Access Compliance Report

Public Rights-of-Way

(Pedestrian Signals)

Intersection ID: N/A	Main Street:	Cross Street: N/A	Location: N/A
ADA ID: B69155FC615F	Signal Type: One Push Button-Non APS	Overall Compliance: No	Severity Score: BTN 1: N/A BTN 2: N/A No BTN: N/A
Codes/Mitigation Info/Possible Solution		Field Measurements/Component Compliance

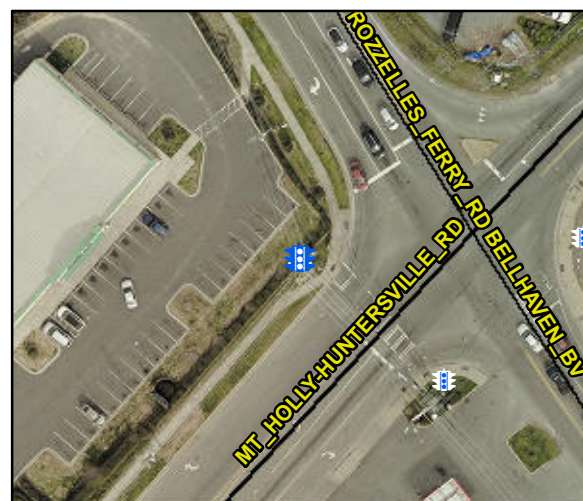
PROW/ADA: R404.2, R404.7.3, R404.7.2

N/A	B 1 FWD Approach Width (in)	N/A	N/A	B 2 FWD Approach Width (in)	N/A
N/A	B 1 FWD Approach Obstruction?	Yes	N/A	B 2 FWD Approach Obstruction?	N/A
N/A	B 1 FWD Approach Obstruction Dist (in)	4.0	N/A	B 2 FWD Approach ObstructionDist (in)	N/A
N/A	B 1 PARA Approach?	Yes	N/A	B 2 PARA Approach?	N/A
N/A	B 1 PARA Approach Constrained?	Yes	N/A	B 2 PARA Approach Constrained?	N/A
No	B 1 PARA Approach Reach (in)	12.0	N/A	B 2 PARA Approach Reach (in)	N/A
No	B 1 PARA Approach Width (in)	48.0	N/A	B 2 PARA Approach Width (in)	N/A
N/A	B 1 PARA Approach Obstruction?	Yes	N/A	B 2 PARA Approach Obstruction?	N/A
N/A	B 1 PARA Approach Obstruction Dist (in)	4.0	N/A	B 2 PARA Approach ObstructionDist (in)	N/A
Yes	B 1 Clear Floor Space Slope (%)	0.9	N/A	B 2 Clear Floor Space Slope (%)	N/A
No	B 1 Clear Floor Space XSlope (%)	4.4	N/A	B 2 Clear Floor Space XSlope (%)	N/A
N/A	B 1 PAR Slope (%)	N/A	N/A	B 2 PAR Slope (%)	N/A
Yes	B 1 Height (in)	36.0	N/A	B 2 Height (in)	N/A

Possible Solutions: Remove and Replace Clear Space.
